Access Compliance Report

Public Rights-of-Way

(Curb Ramps)

Intersection ID: 44487	Main Street: REAMES_RD	Cross Street: FINN_HALL_AV	Location: S
ADA ID: A0244429D369	Ramp Type: Perp	Initial Pass/Fail: Fail	Overall Compliance: No
			Severity Score: 21.25

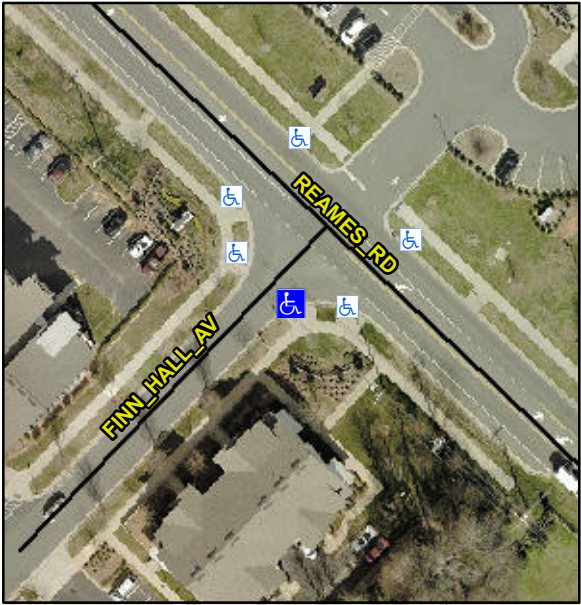
Codes/Mitigation Info/Possible Solution			Field Measurements/Component Compliance		
	Possible Solutions:		Compliance	Description	Data
	Remove & Replace Entire Ramp.		Yes	Ramp Length (in)	96.0
			No	Ramp Width (in)	46.0
			N/A	Flare Type LT	N/A
			N/A	Flare Slope LT (%)	N/A
			N/A	Flare Traversable LT?	N/A
			N/A	Landing Length (in)	N/A
			N/A	Landing Width (in)	N/A
			N/A	Landing Slope (%)	N/A
			N/A	Landing X Slope (%)	N/A
<p>Surveyor Notes:</p> <p>N/A</p>			N/A	Landing Curb? (Y/N)	N/A
			N/A	Shared Landing?	N/A
			N/A	Gutter Ponding?	N/A
			N/A	Gutter Lip Ht (in)	N/A
			No	Painted X Walk1?	N/A
				X Walk 1 Direction	To NW
			N/A	X Walk 1 Width (in)	N/A
				X Walk 1 Slope (%)	4.4
				X Walk 1 X Slope (%)	3.6
			N/A	Ramp inside XWalk1?	N/A
<p>PROW/ADA:</p> <p>Not Found, R304.5.1, R304.5.3</p>			N/A	Road Slope (%)	N/A
			N/A	Road X Slope (%)	N/A
			N/A	Any Obstructions?	N/A
				Obstruction Type	
			N/A		
			N/A		
			N/A
